October 31, 2011

Procedure Memorandum No. 60

Amending the Guidelines and Standards for Flood Hazard Mapping Partners

Title: Revision to Figure D.2.8-3, Wave Runup Guidance for Vertical Wall, From Shore Protection Manual (USACE, 1984)

This Document is Superseded.
 Figure D.2.8-3 Wave Runup Guidance from Vertical Wall, From Shore Protection Manual
 (USACE, 1984)
For Reference Only.

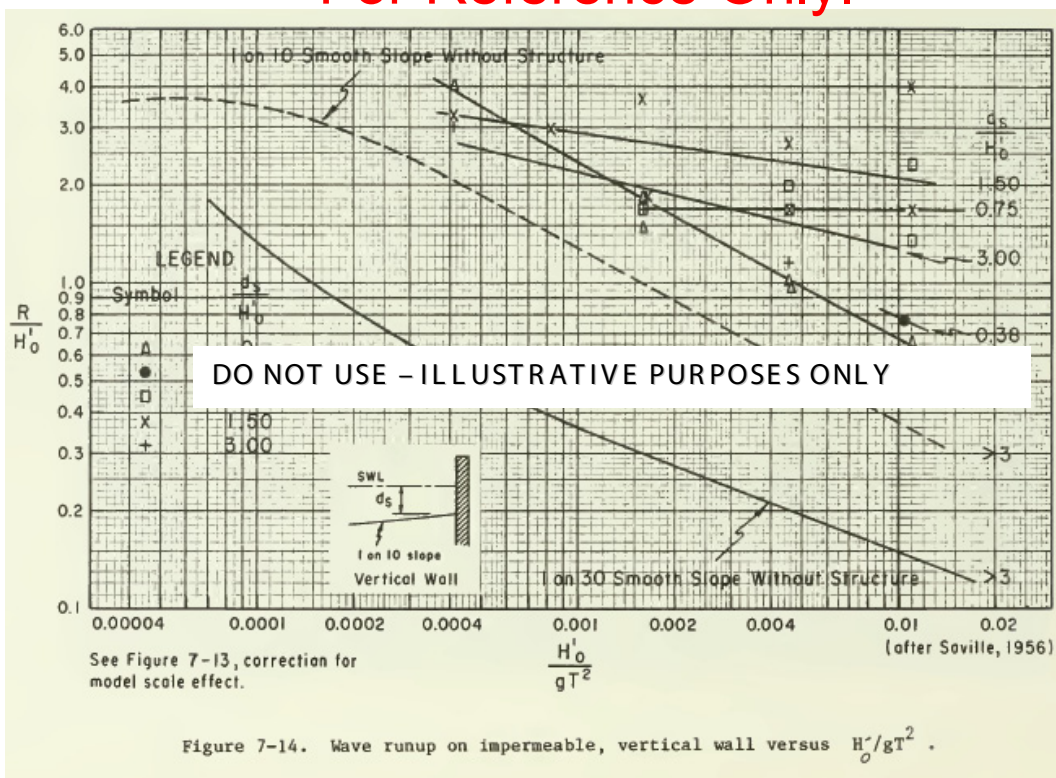
The procedure for estimating wave runup on vertical structures relies on the use of Figure D.2.8-3, shown below, provided the wave steepness and structure depth. The figure cites both the *Shore Protection Manual* (SPM) and Saville's paper (1956). However, a comparison of the *Guidelines'* Figure D.2.8-3 to the SPM's Figure 7-14, also below, revealed an inconsistency in the coefficient for structure depth, d_s/H_0 , listed for the uppermost curve.

The *Guidelines* shows a depth of 0.60 for the topmost curve while the SPM lists the same curve as having a depth of 1.50. The legend of Figure D.2.8-3 of the *Guidelines* also identifies this same curve as having a depth of 0.50. The legend in Figure 7-14 of the SPM again shows a value of 1.50. A review of Saville's work, Fig. 3, below, confirmed the original coefficient published was 1.5.

For all new detailed coastal study starts in Fiscal Year 2010 making use of this procedure for estimating wave runup on vertical structures, the coefficient listed for the uppermost curve is redefined to be 1.50. Letters of map revision submitted for studies initiated or completed prior to issuance of this procedure memorandum shall use the redefined coefficient of 1.50. A corrected Figure D.2.8-3, presented below, contains these changes.

Corrected Figure D.2.8-3:
